Year 3 Monitoring Report

CATBIRD SITE

NCDMS Project #100022 (Contract #7186)
USACE Action ID: SAW-2017-01506
DWR Project #20171039

RE: Catbird Site: Year 3 Monitoring Report (NCDMS ID 100022)

Figure 2 - CCPV MY3

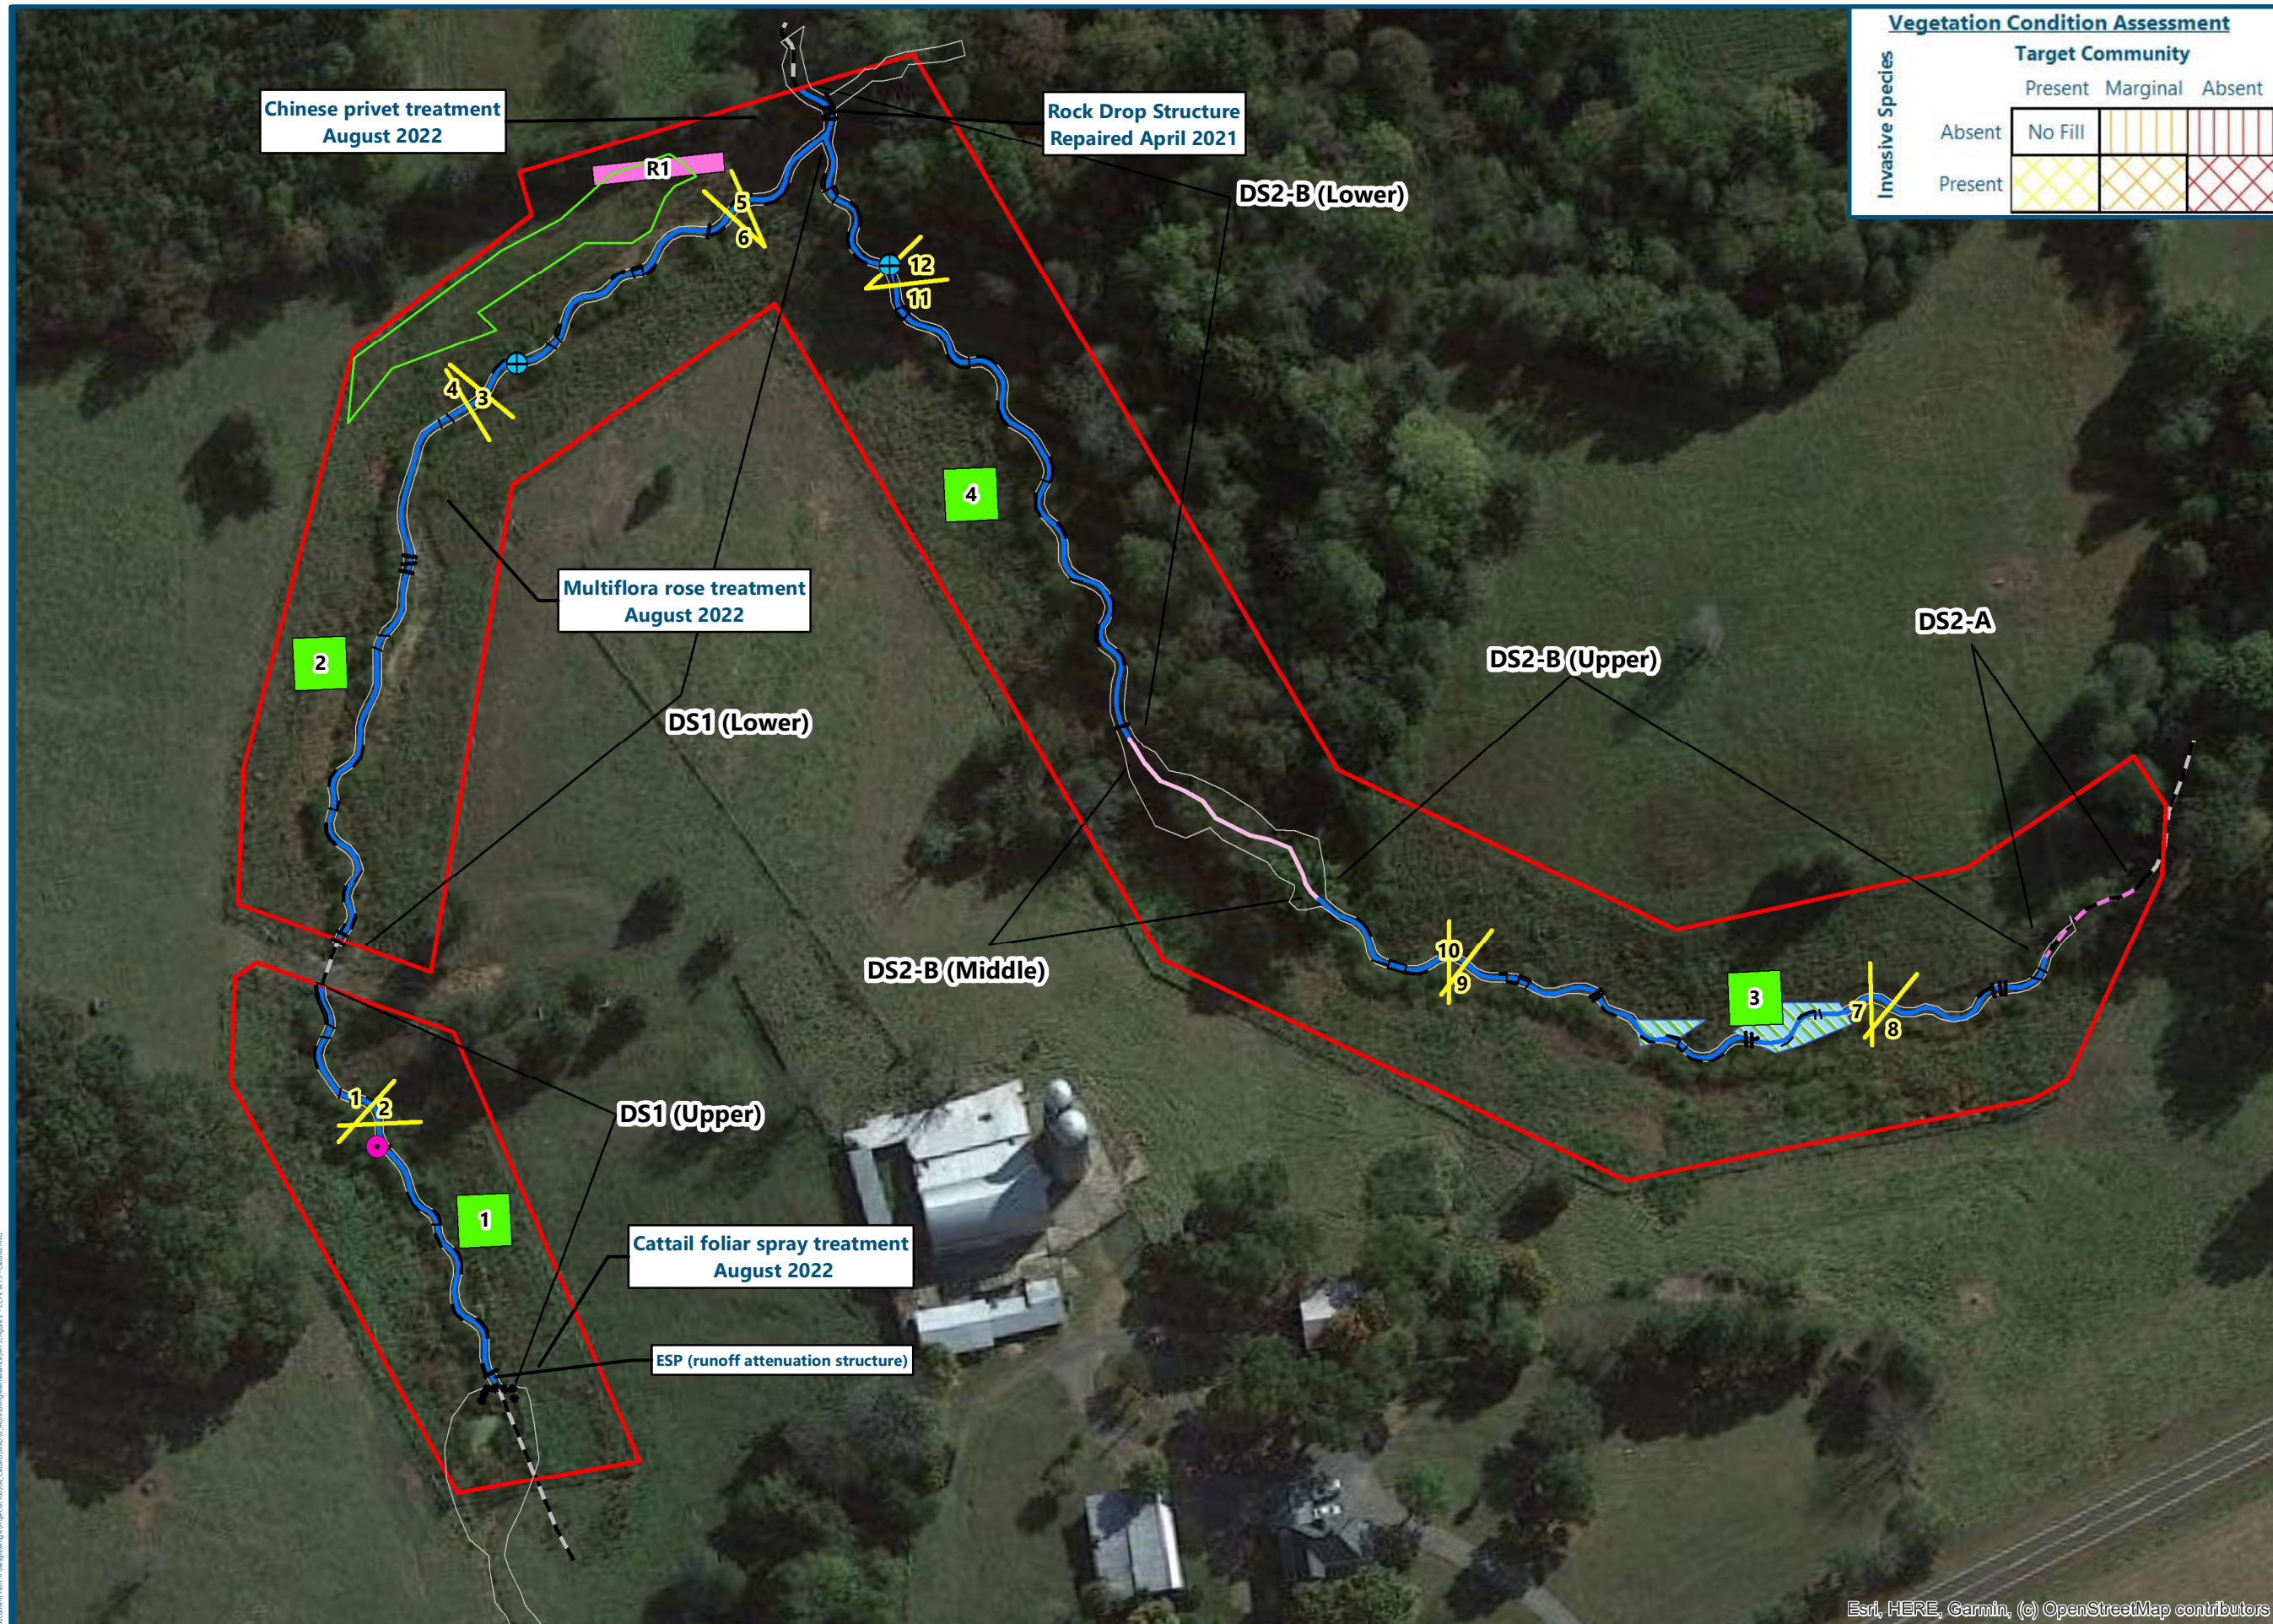
- CCPV – Supplemental planting area legend symbology (hatching pattern) does not match the apparent supplemental planting area on the CCPV.
[The CCPV planting area now symbology matches the legend.](#)
